Contract #: 04-0120F4Cty: SF/ALA Rte: 80 PM: 13.2/13.9File #: 69.25B**QUALITY ASSURANCE -- NON-CONFORMANCE REPORT****Location:** Changxing Island, Shanghai, China**Report No:** NCR-000902**Prime Contractor:** American Bridge/Fluor Enterprises, a JV**Date:** 23-Nov-2010**Submitting Contractor:** Zhenhua Port Machinery Company, Ltd (ZPMC), Changxing Island**NCR #:** ZPMC-0864**Type of problem:**

Reference Description: New Weld Procedure Not Being Followed (Rager/McQuaid)**Description of Non-Conformance:**

Dear: Mr. Charles Kanapicki
Attention: Mr. Thomas Nilsson Project/Fabrication Manager
Subject: NCR No. ZPMC-0864

Job Name: SAS Superstructure
Document No: 05.03.06-000859

The weld is identified as DP-3104-001-44

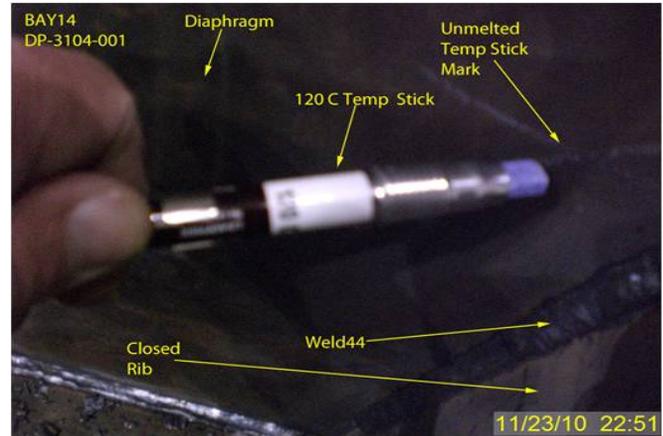
Caltrans QA in process observations of the fabrication of DP-3104-001 discovered the following issue(s):
 ZPMC welding personnel did not appear to be following the NEW WELD PROCEDURE (Rager / McQuaid)
 The following requirements were not followed:

5. Postweld Thermal Treatment (5A, 5B, 5D)

The welding process used was Flux Cored Arc Welding (FCAW)

The area was being preheated using electric strip heaters.

The weld is a Fillet joining Closed Rib to Deck Panel Diaphragm

The weld is identified as DP-3104-001-44

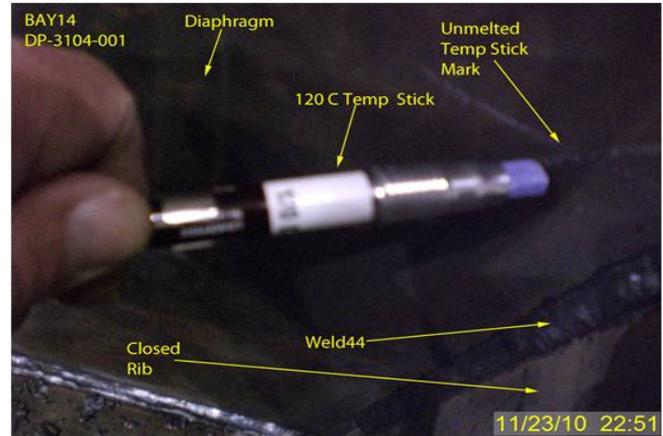
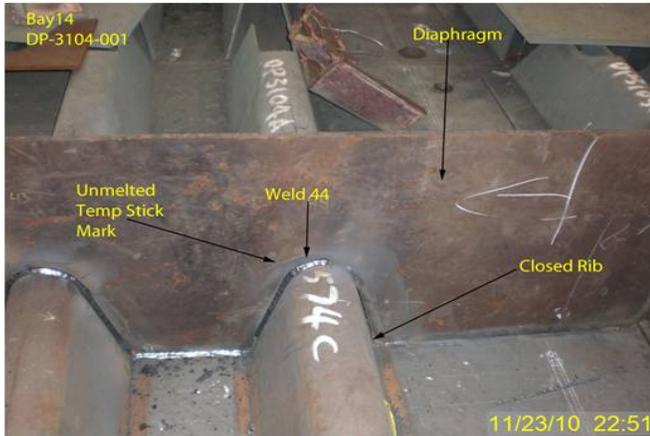
Caltrans QA in process observations of the fabrication of DP-3104-001 discovered the following issue(s):
 ZPMC welding personnel did not appear to be following the NEW WELD PROCEDURE (Rager / McQuaid)
 The following requirements were not followed:

5. Postweld Thermal Treatment (5A, 5B, 5D)

The welding process used was Flux Cored Arc Welding (FCAW)

The area was being preheated using electric strip heaters.

The weld is a Fillet joining Closed Rib to Deck Panel Diaphragm
